**FOURTH LINE WELL FIELD EXPANSION, ACTON, MUNICIPAL CLASS ENVIRONMENTAL ASSESSMENT  
STUDY – PROJECT FILE**

Appendix C External Agency Comments  
January 21, 2015

## CVCA Comments Review Presentation and Discussion

# Environmental Impact Assessment Fourth Line Well Field

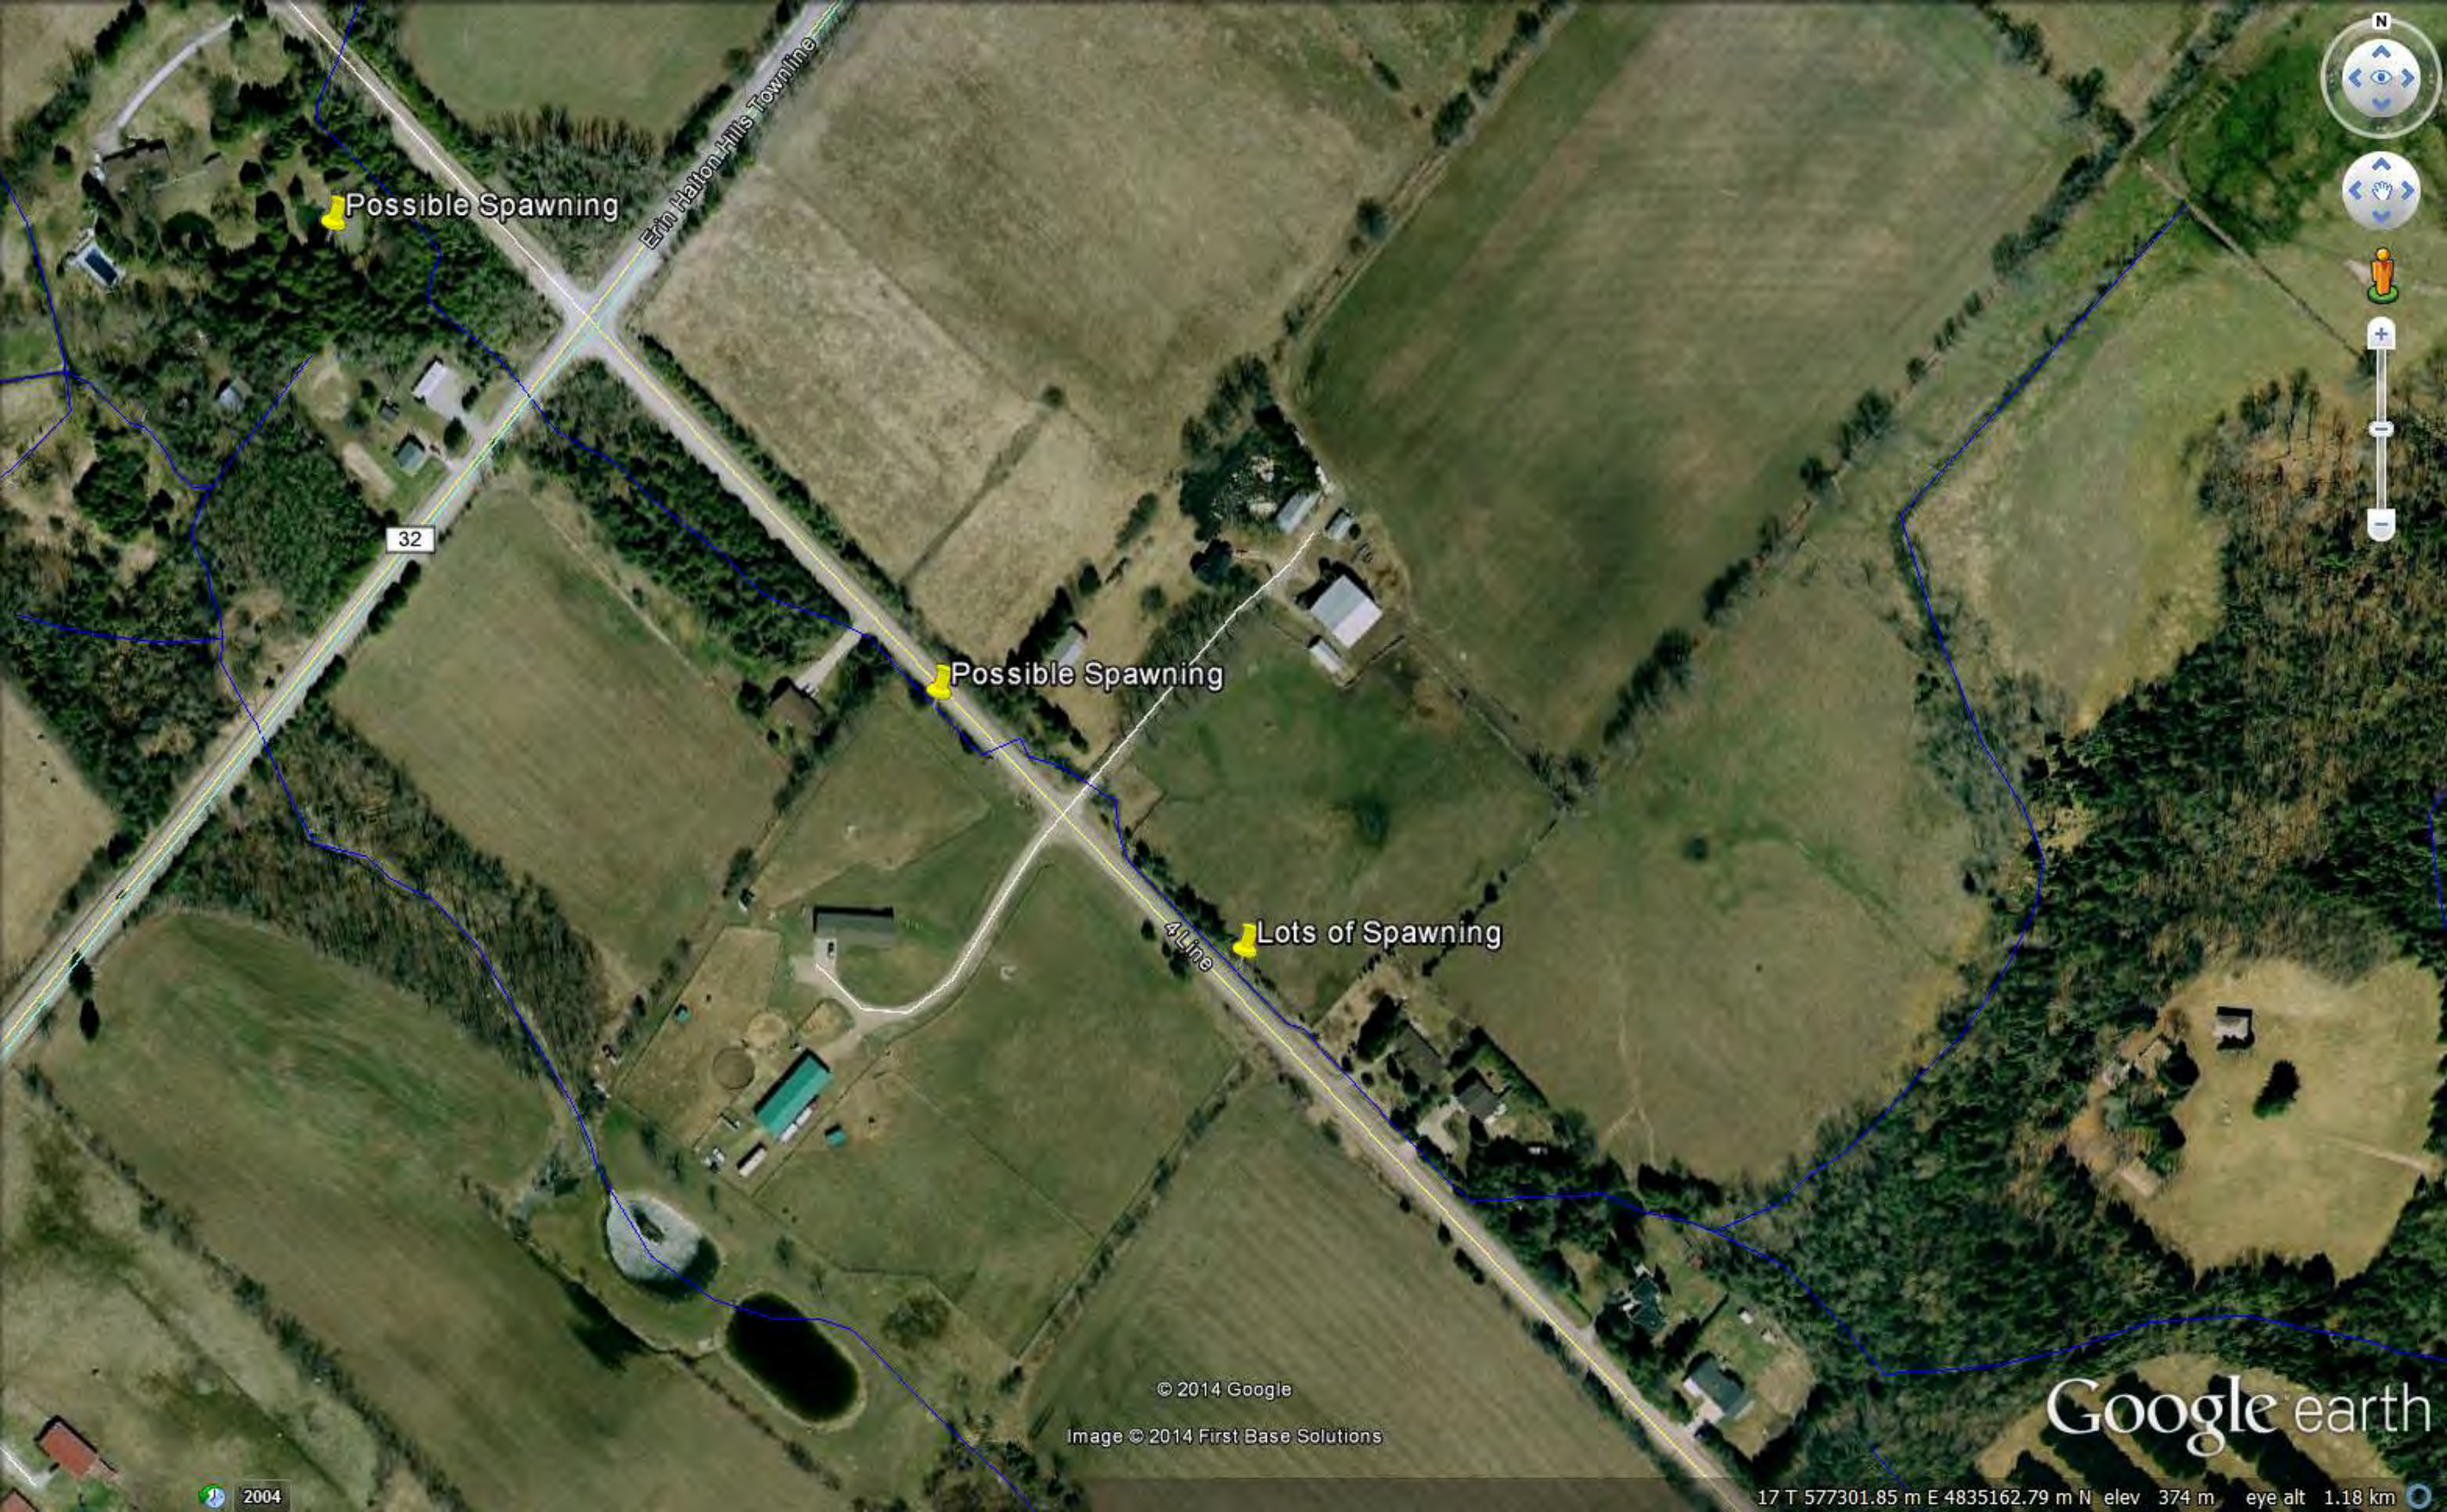
CVC staff have undertaken a spawning survey in the area of the 4th Line Well. See Jon's comments below.

Could you overlay the surficial geology mapping onto the spawning information. I also think this would be beneficial information to include in your report.

On Wednesday I walked a few reaches of the Beeney Creek at 4<sup>th</sup> Line and 32<sup>nd</sup> Sideroad. We were able to get onto the property upstream of the pumping station and saw some possible redds/spawning activity but nothing I would consider to be confirmed. There was also one Brook Trout in the pond. We did see a lot of definite spawning in the stream on the east side of 4<sup>th</sup> Line where it runs parallel to 4<sup>th</sup> Line and some possible spawning in a couple of spots where it runs beside the west side of 4<sup>th</sup> Line. It is interesting that the area where we saw the spawning is the lense of different surficial material. I would be interested in overlaying the two pieces of information to see how well they match up.

# Hydrogeological Comments

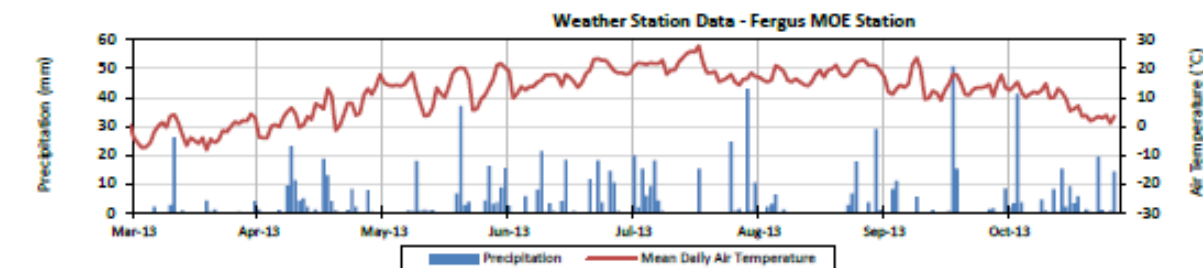
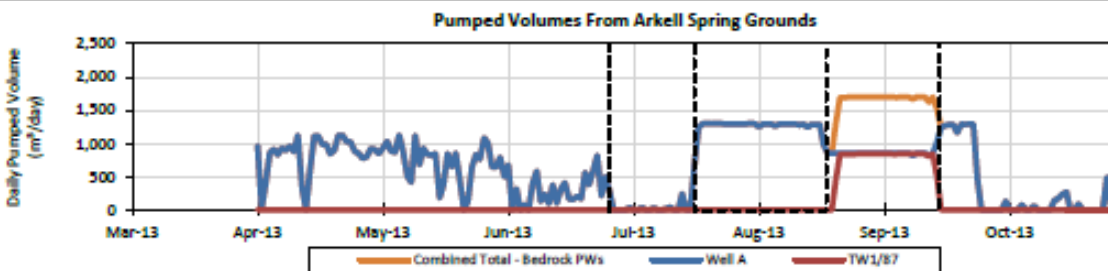
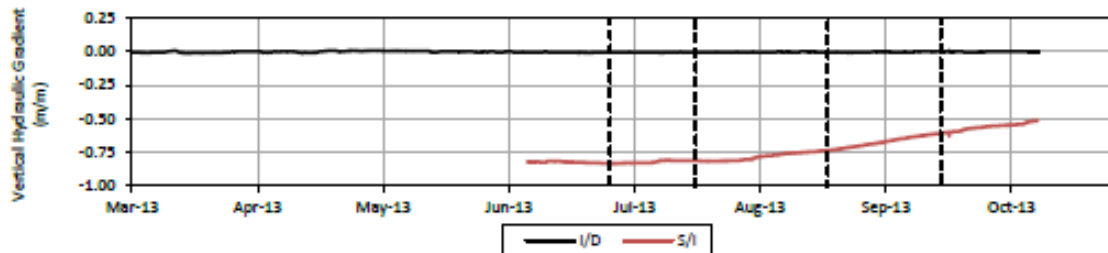
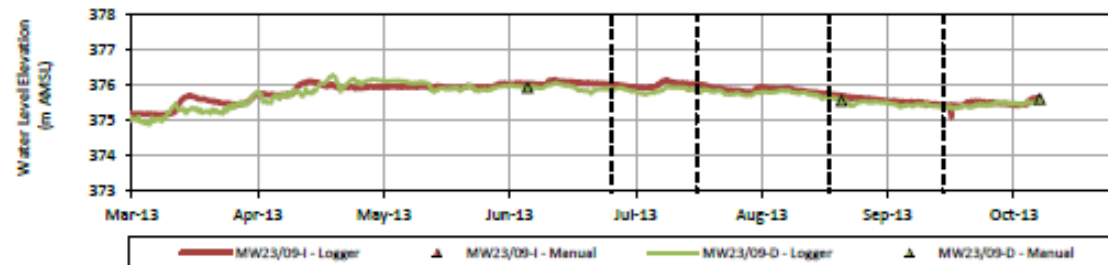
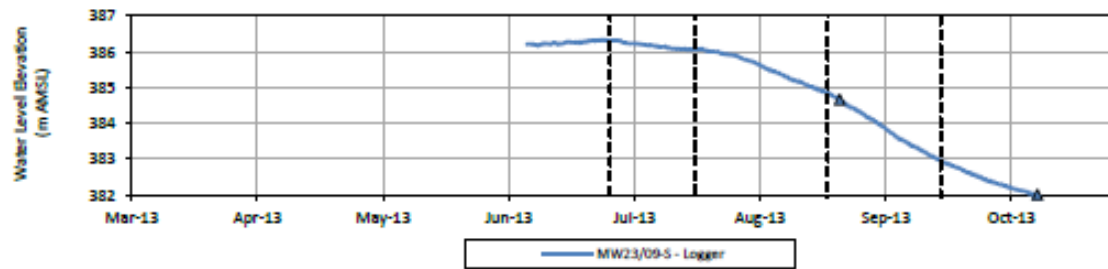
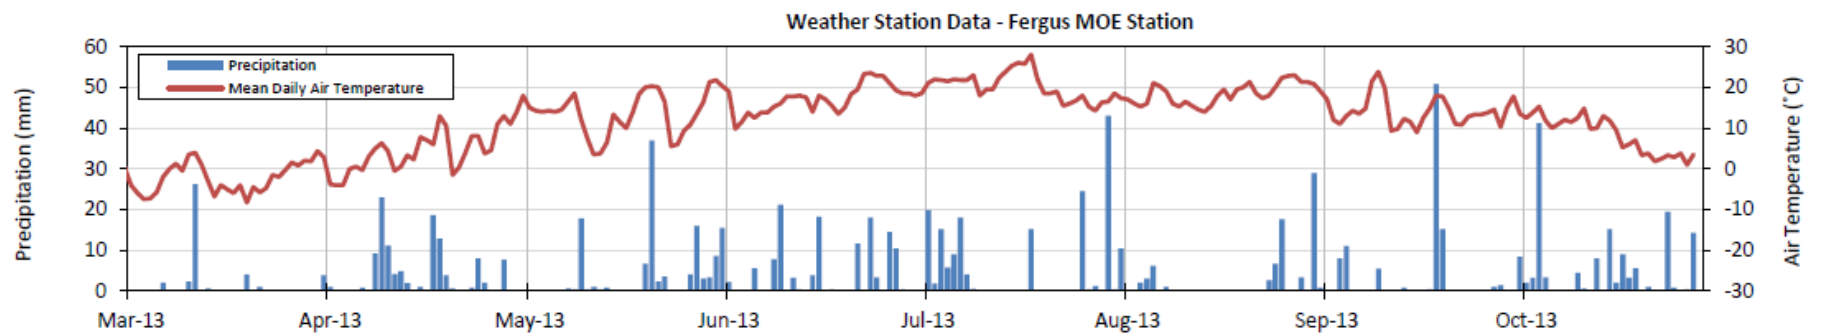
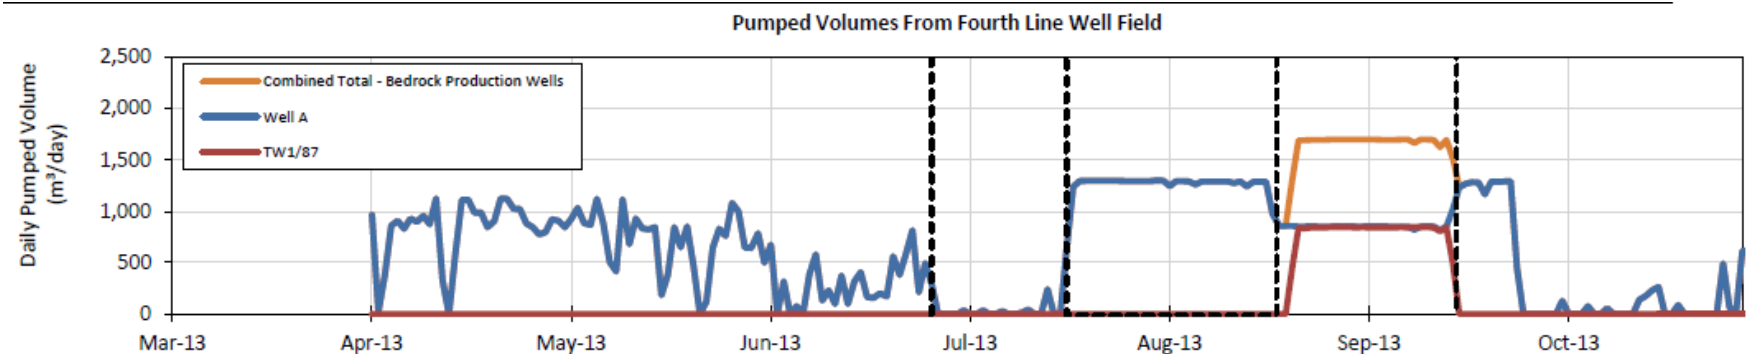
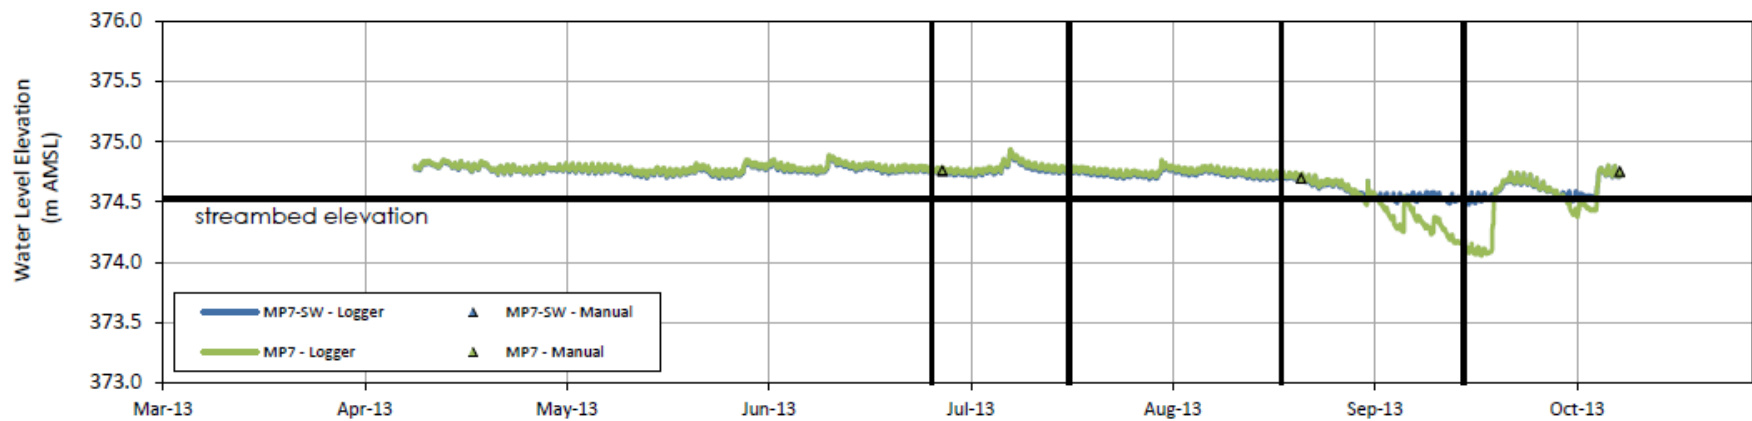
1. Drawdown of 0.5m (Figure 16) is significant for the hydrology of wetland and fisheries. Considering the hyperbola form of the influence cone, the pumping may influence larger area. The monitoring coverage should extend beyond the 0.5m drawdown contour. It is especially so for wetland monitoring stations. The drawdown of Figure F-10 (hydrograph of MW23) has shown this fact. Further analysis is required or explanation of why 0.5 m level was selected.

Page 4.18 (Figure 16): The page 21 of PTTW Manual requires that the influence are “defined by the radius of influence projected after 20 years of pumping at the maximum daily rate for the maximum requested number of days”. Since the report will be used for PTTW application, the influence zone should have been defined / calculated in accordance with the manual.

2. Page 4.3 (Figure 12b, Figure F-3a): The change of levels for MP7 during pumping was assumed to be caused by weather conditions, but no expression was recorded in the surface water at MP 7, although surficial groundwater levels became lower. Given this, it does not appear that low precipitation is the sole factor at play. Further analysis or explanation is required.
3. Page 4.12 – 4.13(Figure F-6, 9, 10): The report concludes that that decline in the water levels in bedrock wells MW2A, MW5A and MW23 was not a response to the pumping test, but to low precipitation. Additional explanation is required.

## Hydrogeological Response 2

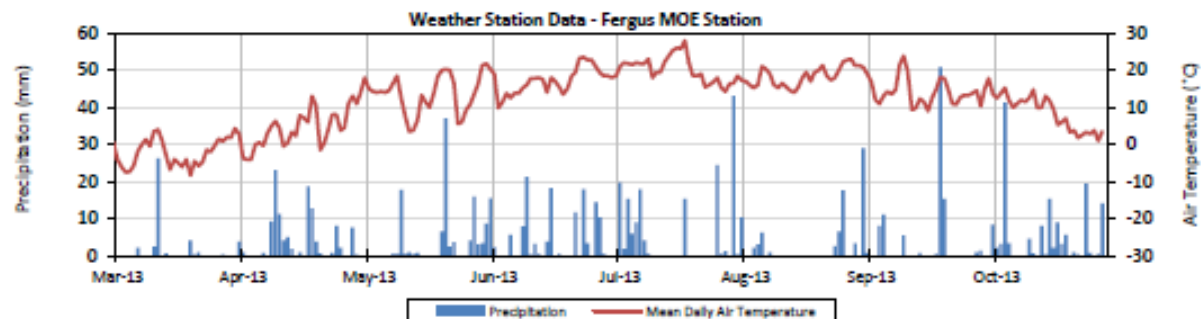
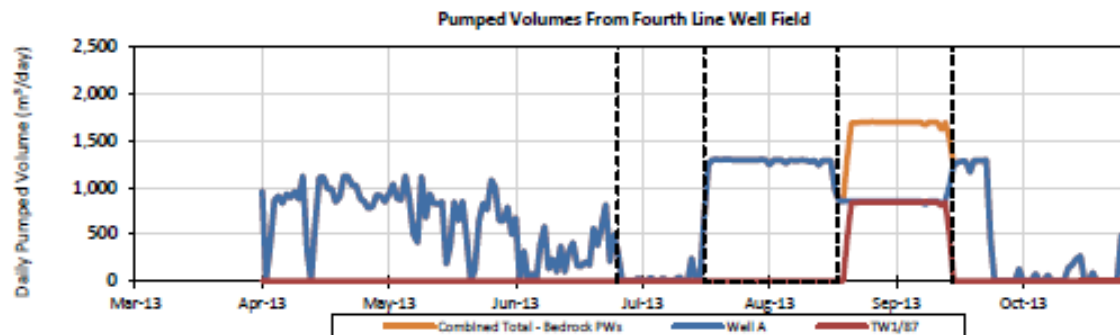
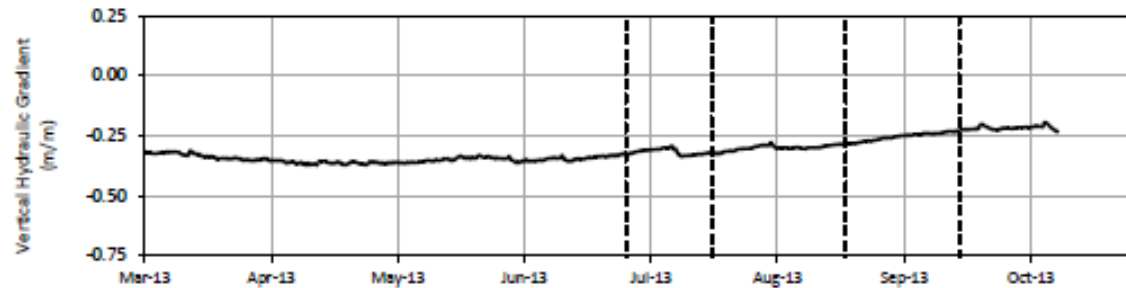
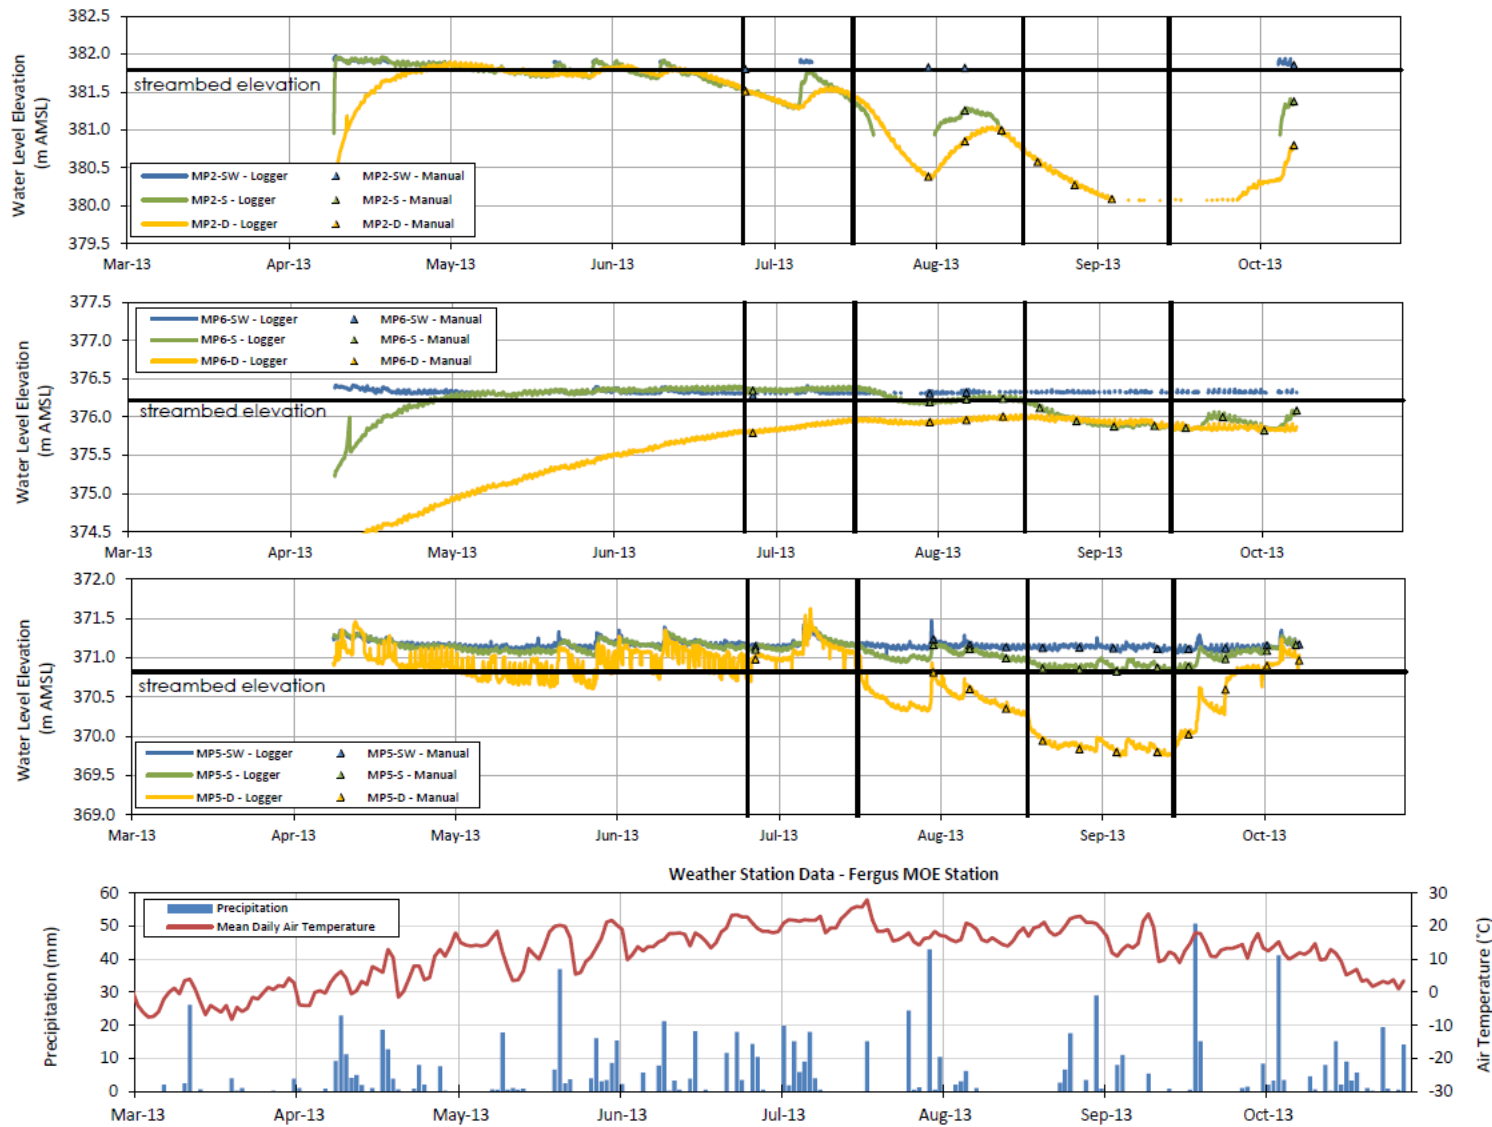
### **Response to CVCA Comment 2 – About Station MP7**

Stantec showed the data plots for this station, where surface water dries and then the lower aquifer level begins to change. The effect is reversed when surface water returns.

CVCA staff noted that the lowest response does appear to coincide with the time of highest pumping. Stantec noted that on the scale of these plots, it does appear so, but if we lowered the scale to the 15 minute data intervals, the response does not show it being tied to pump rate changes. Again, Stantec cited the effect of the Wentworth Till, which is present in this location.

Stantec to provide expanded data scale to show 15 minute intervals for the end of pump testing in October and the subsequent major rain event.
